# Mendota Pool Bypass and Reach 2B Improvements Project

**Final  
Environmental Impact Statement/Report**

**SAN JOAQUIN RIVER  
RESTORATION PROGRAM**

Final  
July 2016

FIGURE 17.—Land subsidence, 1926-72, Los Banos-Kettleman City area. Compiled as sum of subsidence for 1926-69 (fig. 15) and for 1969-72 (fig. 18).

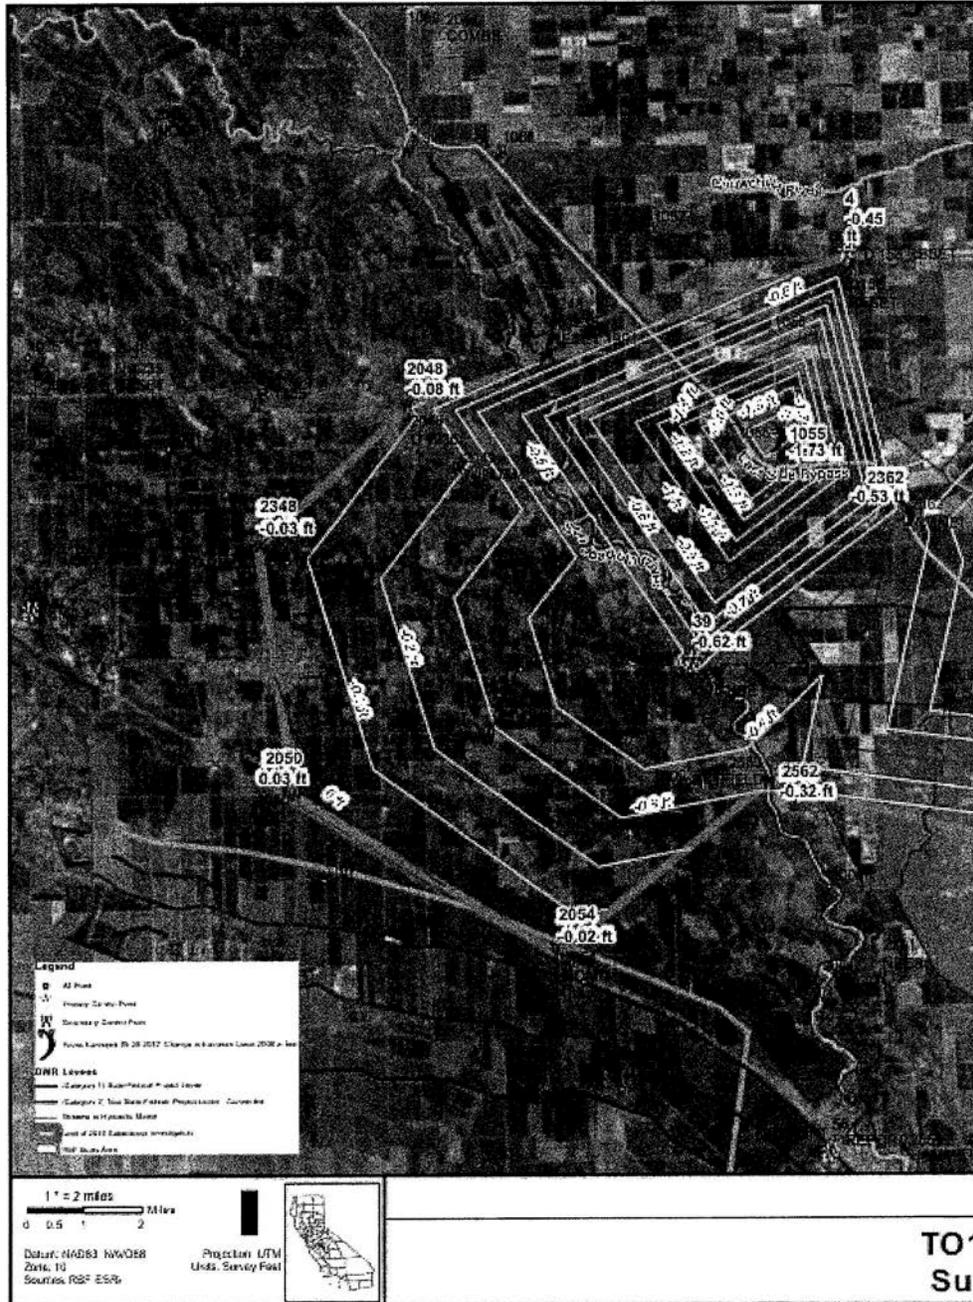
**O-EC-80** 13.2. The rates, extent and threats that subsidence exerts on the Project needs to be thoroughly discussed. Subsidence in the patterns (if not the rates) as shown on figure 13-4, if they were to continue from this time forward, would reduce the available flow rate capacity in the river and bypass system, likely below the rates needed for successful restoration. This is especially the case including the new subsidence that is occurring in the Red Top area.

**O-EC-83** 13-5. There is discussion of subsidence in the San Joaquin Valley stating that maximum land subsidence rates occurred in the 1960s. (Page 13-9 discusses the Tulare Lake Region.) Figure 13-4 illustrates land subsidence contours in the San Joaquin River and Tulare Lake hydrologic regions from 1926 to 1970. The discussion completely ignores the more recent increased rates of subsidence documented in the vicinity of Sack Dam, which has serious implications for the SJRRP and its component projects.
